Consideration of Geochemical Issues in Groundwater Restoration at Uranium In-Situ Leach Mining Facilities

U.S. Geological Survey

**U.S. Nuclear Regulatory Commission
Office of Nuclear Regulatory Research
Washington, DC 20555-0001**

Figure 12. Simulation 1 results. Oxic influent groundwater. Calcite and goethite initially present. Mass transfer coefficient = 10.

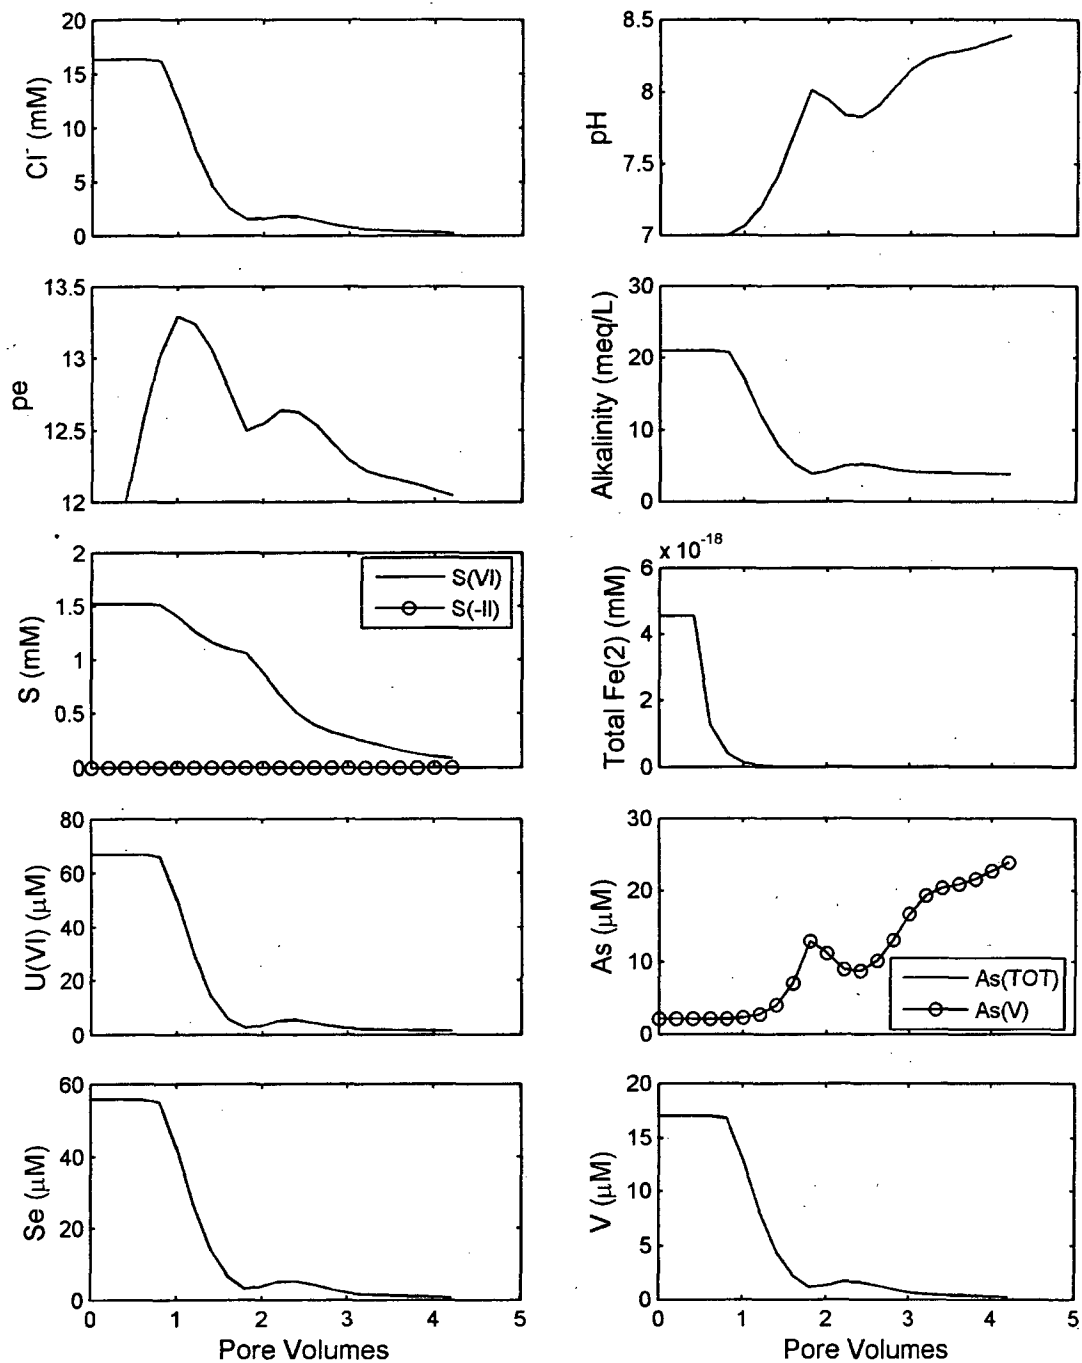
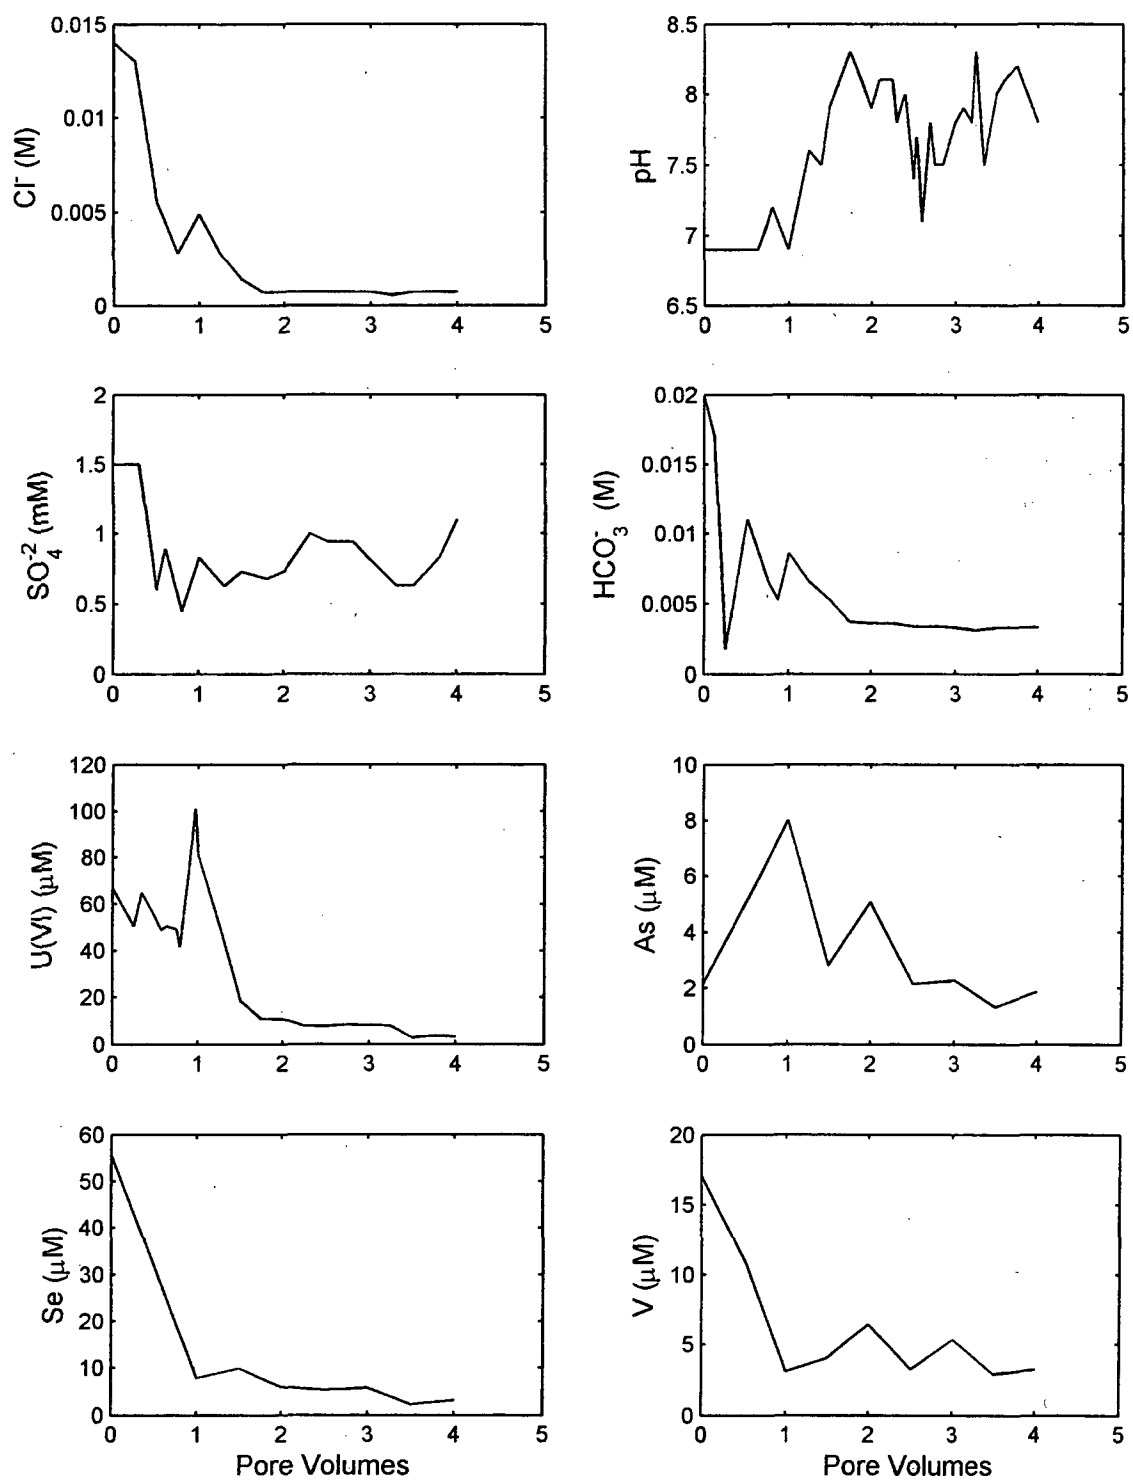
2-16. Comment: The results of Simulation 1 (Figure 12) are compared with the Ruth data (Figure 11). For illustrative purposes, it might be helpful to have another figure with the both the simulation results and the field data. Also, it would be helpful if the differences between the Ruth test and Simulation 1 were noted. For example, how many pore volumes were removed during ground water sweep during the Ruth test (and how was 'pore volume' defined for the Ruth test)?
